**MONTGOMERY COUNTY HISTORIC PRESERVATION COMMISSION**  
**STAFF REPORT**

<b>Address:</b>	21 Quincy Street, Chevy Chase	<b>Meeting Date:</b>	5/27/2020
<b>Resource:</b>	Contributing Resource <b>Chevy Chase Village Historic District</b>	<b>Report Date:</b>	5/20/2020
<b>Applicant:</b>	Andrew and Jennifer Tulumello (Wouter Boer, Architect)	<b>Public Notice:</b>	5/13/2020
<b>Review:</b>	HAWP	<b>Tax Credit:</b>	N/A
<b>Case Number:</b>	35/13-20U	<b>Staff:</b>	Dan Bruechert
<b>PROPOSAL:</b>	Demolition, building addition, and porch construction

*Fig. 1: 21 Quincy St. is building on the left side of a double lot.*

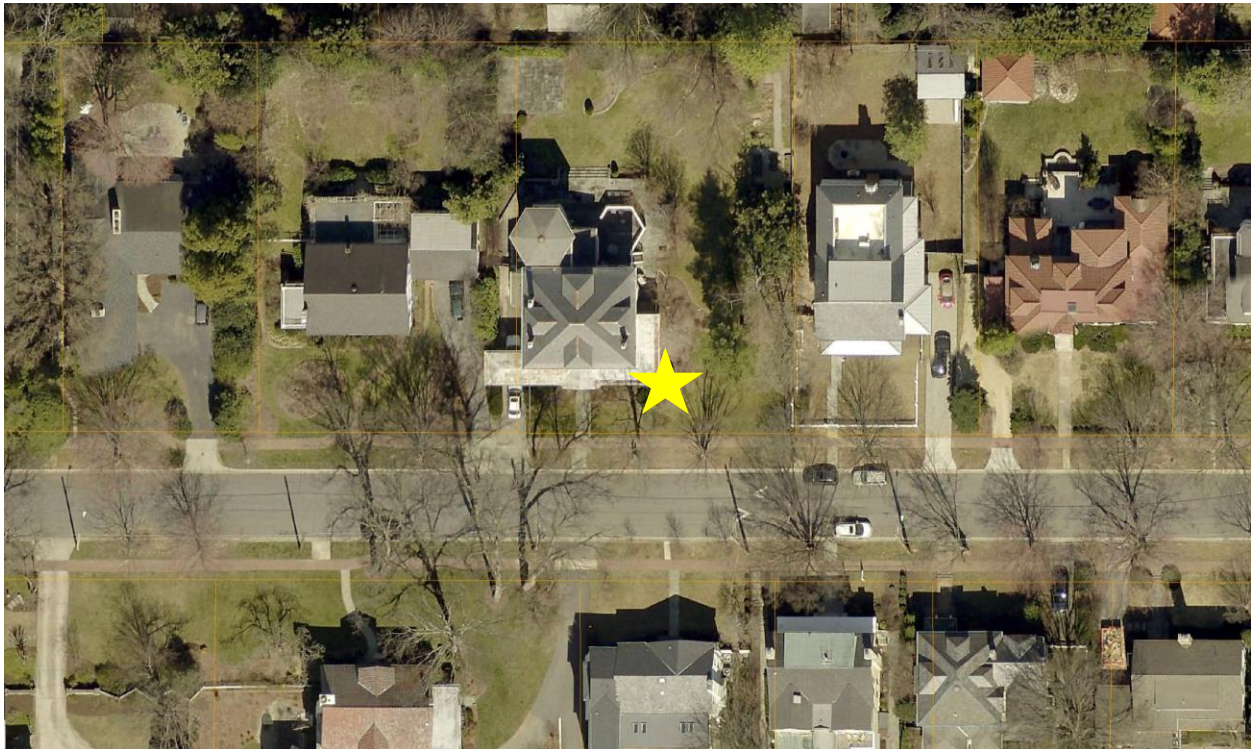
The subject building is a two-story house with a wrap-around porch designed Craftsman and Queen Anne elements. At the rear of the house, there is a hexagonal c.1980 addition and rear deck. On the left side of the house, there is a two-story bump out with an additional entrance.

FIRST FLOOR  
2478 SQFT  
1/8" = 1'-0"

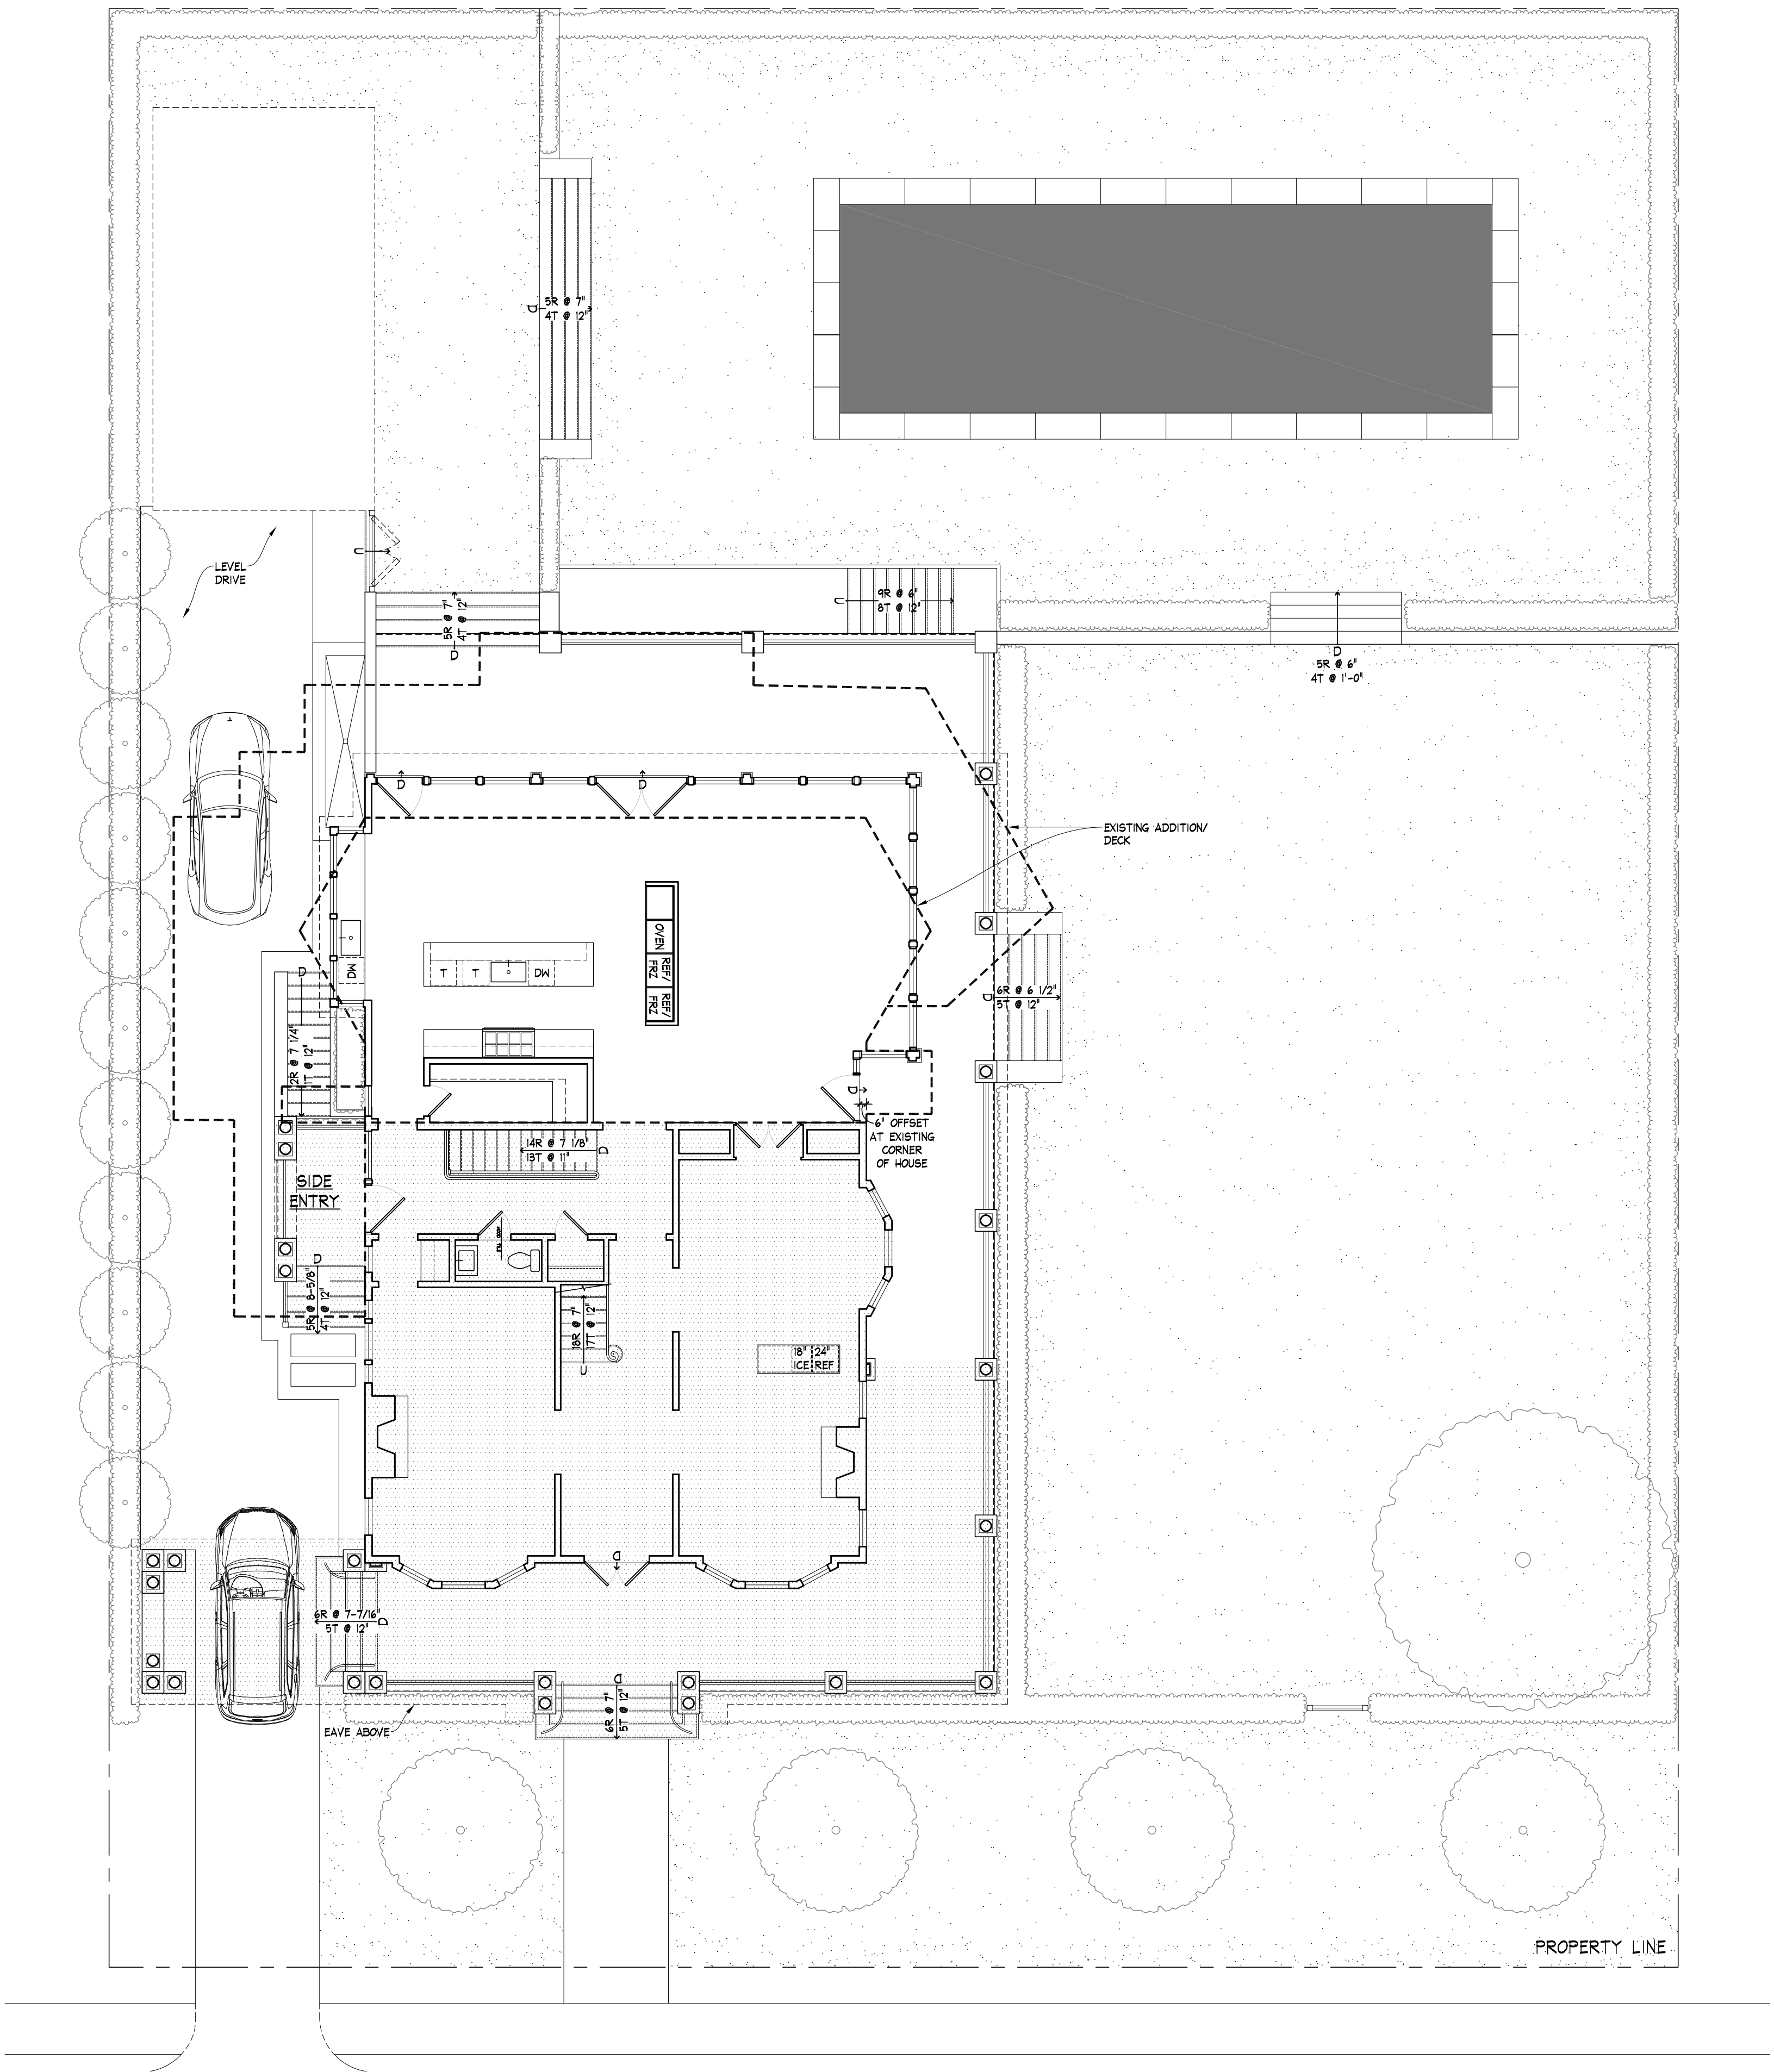
There was one design concern regarding the design of the first floor of the addition. The eastern wall of the addition projects approximately 30" (thirty inches) from the eastern wall plane of the historic house massing. This elevation is more visible than is typical within the historic district because the house was constructed to the western (left) side of a double lot.

The preferred treatment is to have the walls of rear additions inset from the historic construction to provide a level of differentiation between the historic and the new construction; and to make the building addition less visible from the public right-of-way (per the *Design Guidelines*). Insetting the addition also allows the historic construction to maintain primacy on the site. Staff finds that there are no unique lot situations that would limit the ability to inset the east wall of the rear addition, or at the very least making the construction co-planer with the historic house.

These three factors were discussed at length at the Preliminary Consultation and the Commissioners were divided in their recommendations. Some recommended the addition be at least co-planer with the historic wall plane, while others voiced their support for the projecting addition wall for the reasons discussed above. After considering the feedback from the HPC the applicant has decided to retain the size and placement of the first floor of the addition.

Staff concurs with the finding of the Commissioners who determined that the extended first floor would not detract from the historic primacy or character of the historic construction. Staff supports the approval of the first-floor addition under 24A-8(b)(2) and Standards 2, 9, and 10.
